MASSACHUSETTS INSTITUTE OF TECHNOLOGY CAMBRIDGE, MASS. 02139

March 30, 1971

From: J. H. Saltzer

Solving the 113A Data Set Problem
Kenneth T. Pogran
March 27, 1971

FIGURE 1

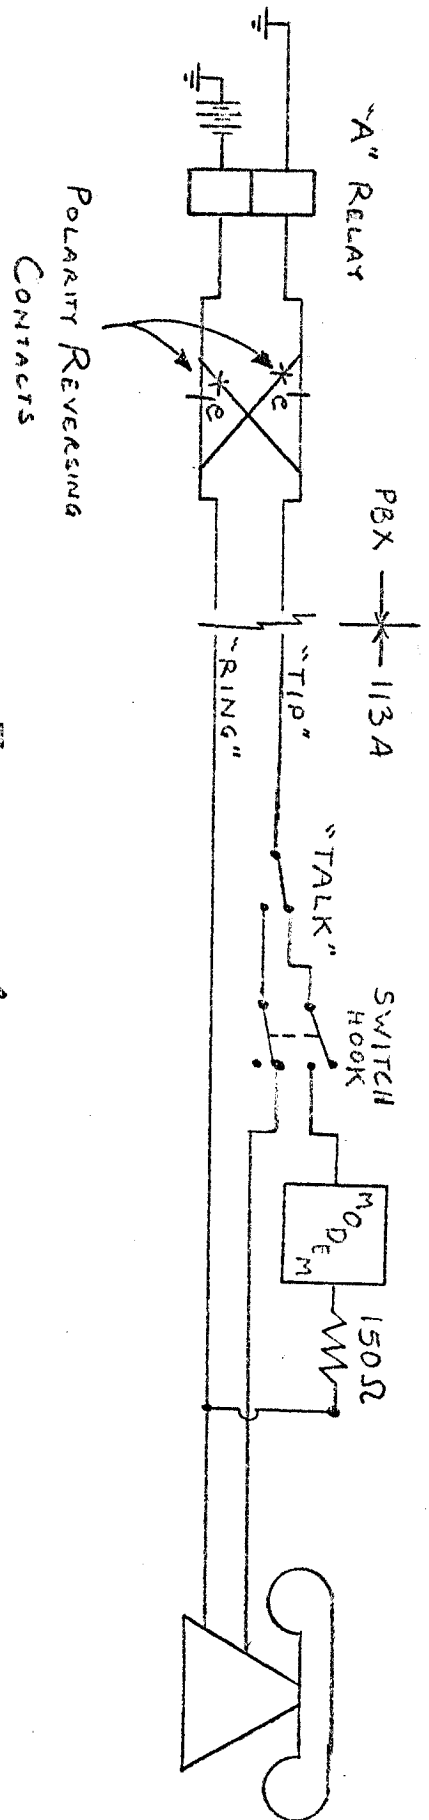
Let us turn to the possibility of modifying the 113A data set itself. Figure 1 is a rough schematic diagram of the circuitry involved in a step-by-step system call in a "talking" state. This diagram will represent well enough, for our purposes, several other stages of a call.

In DATA mode, the 113A data set maintains its "off hook" state by placing a resistive "holding bridge" across the line, to maintain the flow of loop current. Part of this current is used to provide power for the modem. One component of this holding bridge, shown in Figure 1, is a 150 ohm resistor connected to the ring side of the phone line on one end and the modem circuitry on the other.

Now suppose, however, that the data set is left in DATA mode, and the user terminates his console session without hanging up the data set. The computer's data set will be placed on hook by the computer, resulting in the reversion of battery polarity supplied to the calling party to its original state of negative battery on ring and ground on tip. Note that this is the first time during the call when the set has been in data mode with "on hook" battery polarity -- and these are the conditions under which we wish to automatically "hang up" the data set.

FIGURE 2

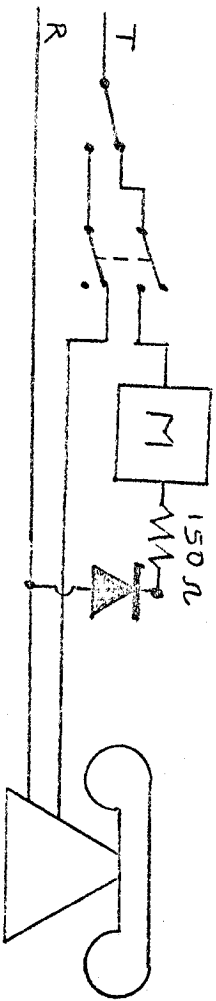
It would seem, then, that what we need to do is prevent current from flowing through the holding bridge of the data set under "on hook" battery polarity, for that will generate the desired on hook condition which will cause the trunk circuit to release the connection, freeing the computer port. We do want current to flow through the holding bridge under off-hook battery polarity, of course. A simple, inexpensive silicon diode, inserted in the circuit at the point shown in Figure 2, will do the job. The point in the circuit shown in Figure 2 is especially suited for field modification of the 113A data set, as installation of the diode may be easily done with a screwdriver in such a manner as to result in a neat job.

With the addition of the diode in the holding bridge circuit, the data set is effectively "on hook" when left in data mode, as opposed to the present situation of being "off hook" when left in data mode. This makes it possible for someone to call a data set which has been left in this state. Without the modification, an off-hook data set would appear "busy" to potential callers. Ringing a telephone line consists of applying 90 volts at 20 Hz, superimposed upon the -48VDC battery supply. The effect this voltage will have on the diode and the other components of the data set must be determined.

During the positive half of the 90VAC ringing current cycle, the actual voltage applied to the line will reach approximately -3 volts. The diode will not be forward biased, no current will flow, and the modem circuit should be protected. On the negative half cycle, the voltage will reach approximately -93 volts. Thus, the diode must have a peak inverse voltage greater than -100 volts. If this is the case, the modem will be protected
